**RE: VENTANA RANCH PARK TRACT 7B-1 (B9-D3). GRADING PLAN FOR GRADING  
PERMIT APPROVAL. ENGINEER'S STAMP DATED JULY 2, 1997.**

**RE: VENTANA RANCH PARK TRACT 7B-1 (B9-D3). GRADING PLAN FOR GRADING  
PERMIT APPROVAL. ENGINEER'S STAMP DATED JULY 2, 1997.**

VENTANA RANCH TRACT 7B-1 PARK SITE  
GRADING PLAN

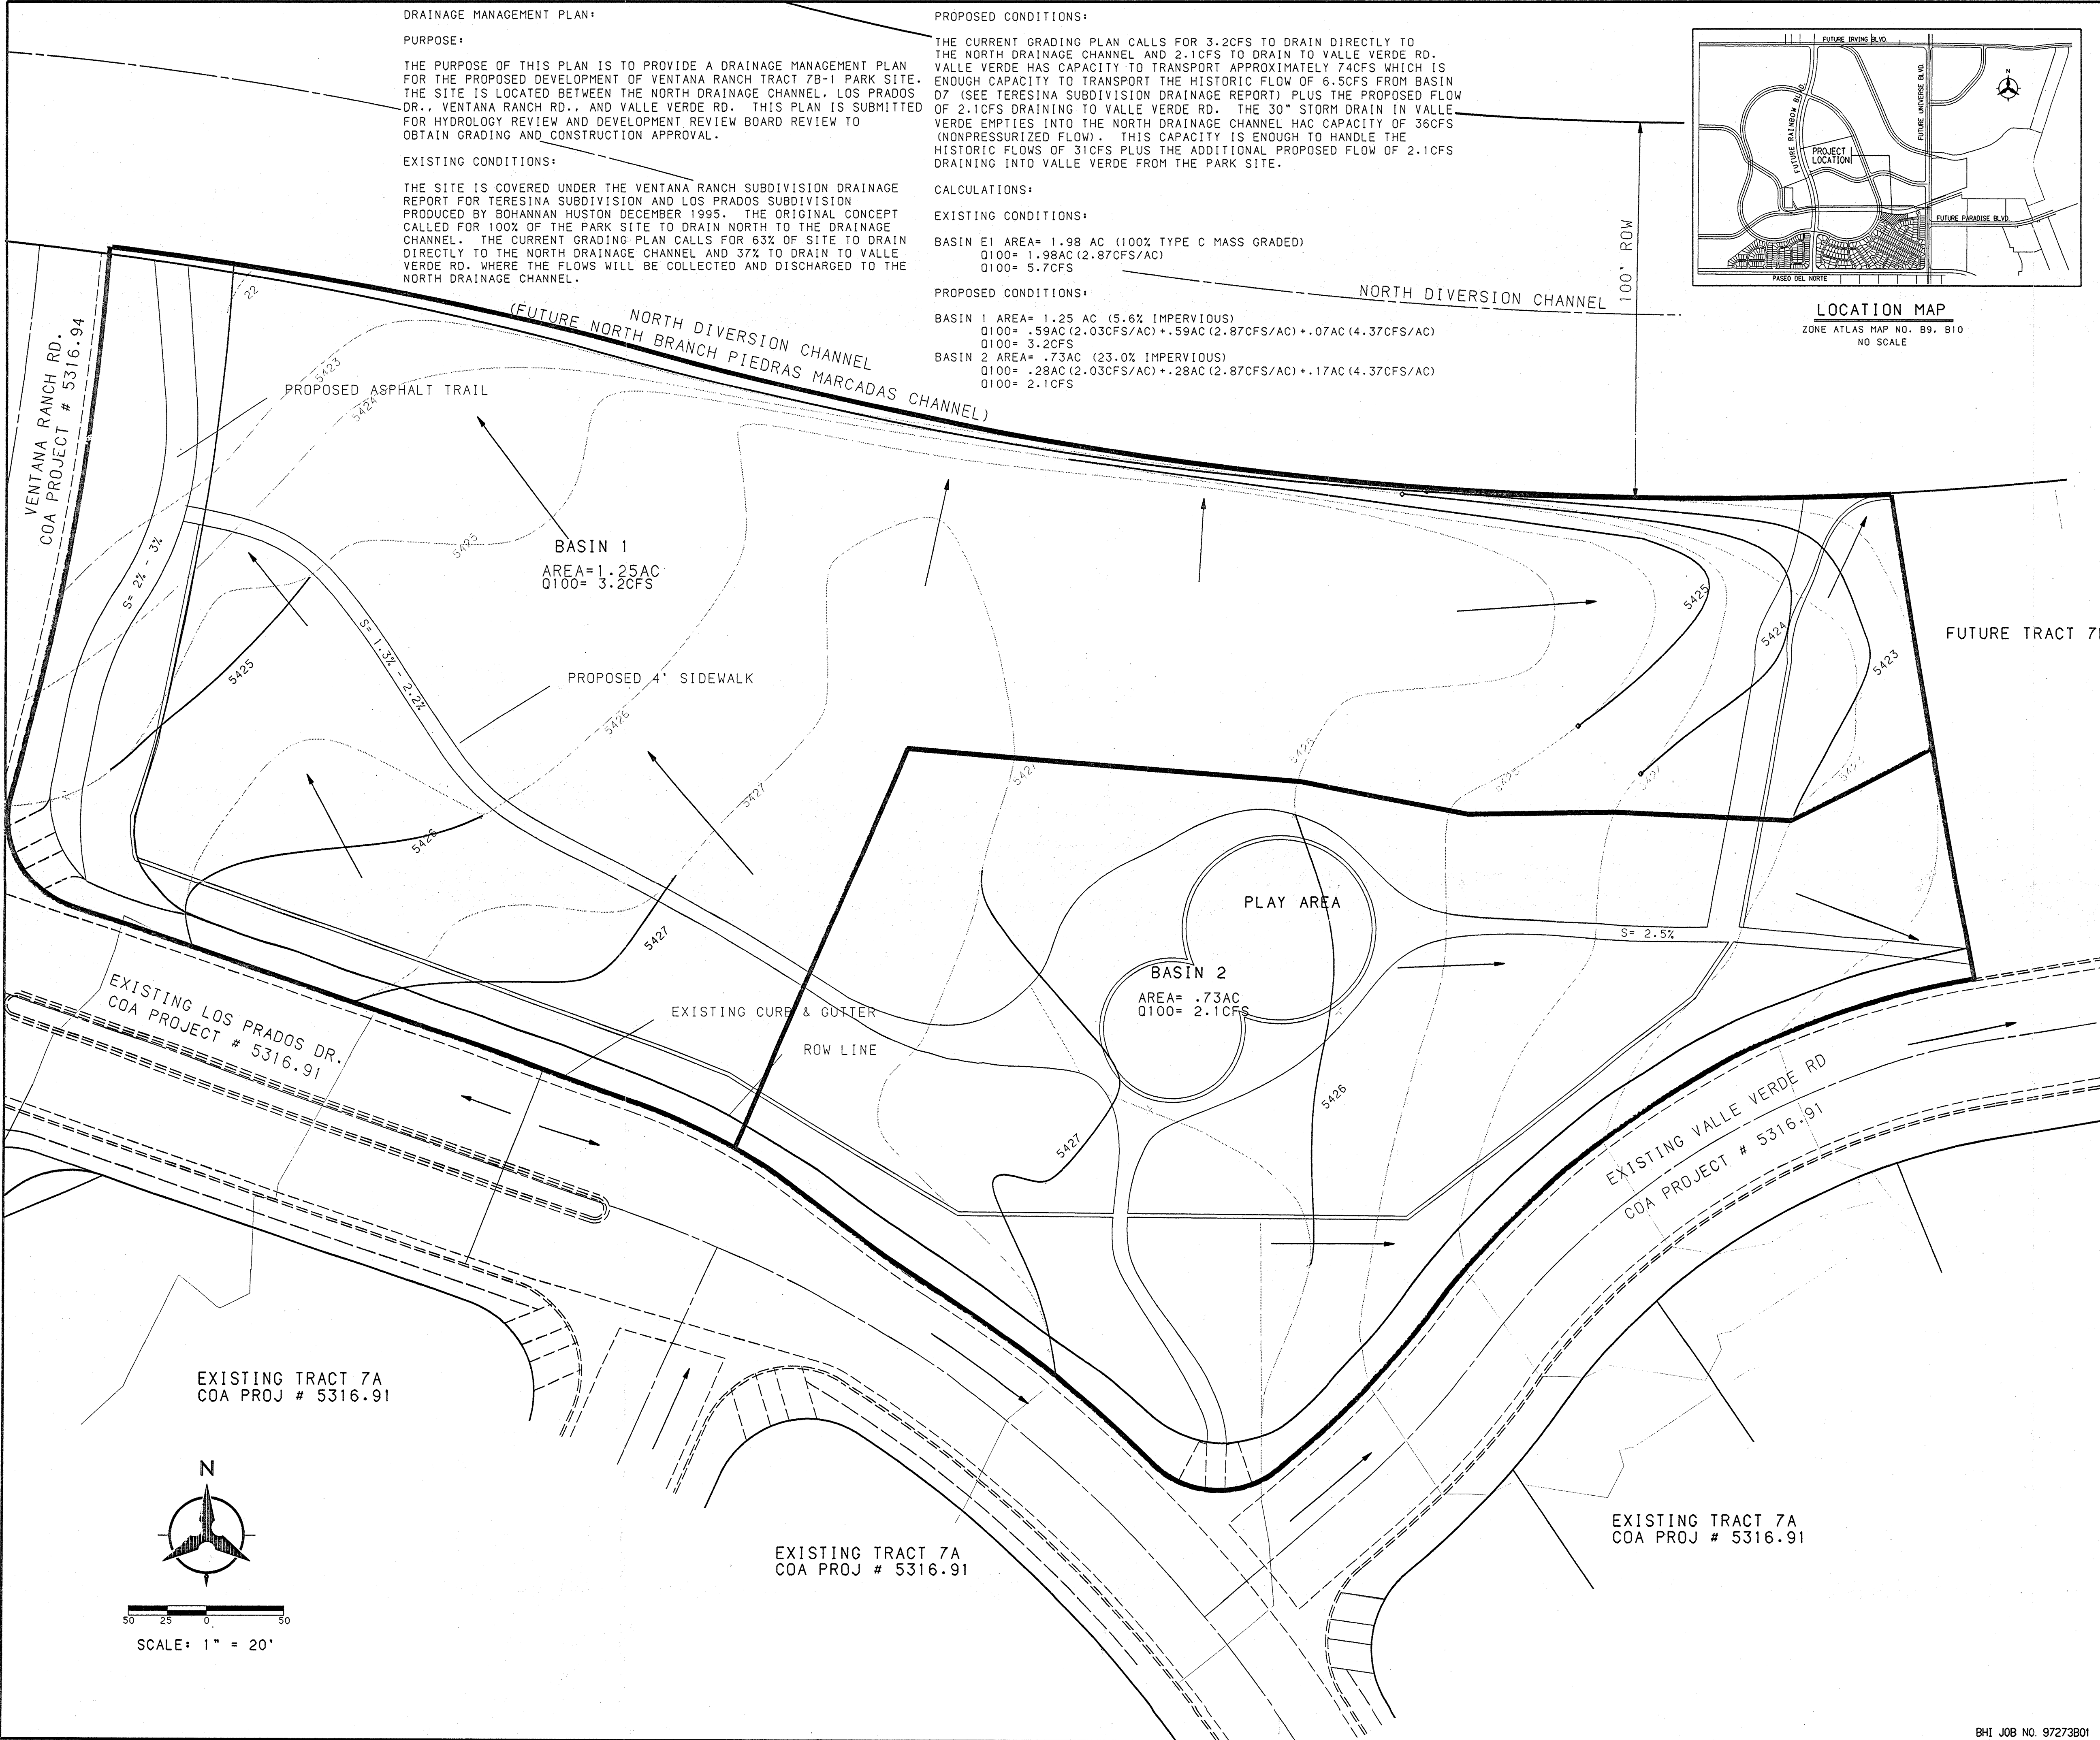
Based on the information provided on your July 3, 1997 submittal, the above referenced project is conditionally acceptable for construction. Prior to grading permit approval, please grade Basin 2 so that all storm water is discharged a one point to Valle Verde Road via a sidewalk culvert.

Be certain to request SO #19 Permit approval with your next submittal.
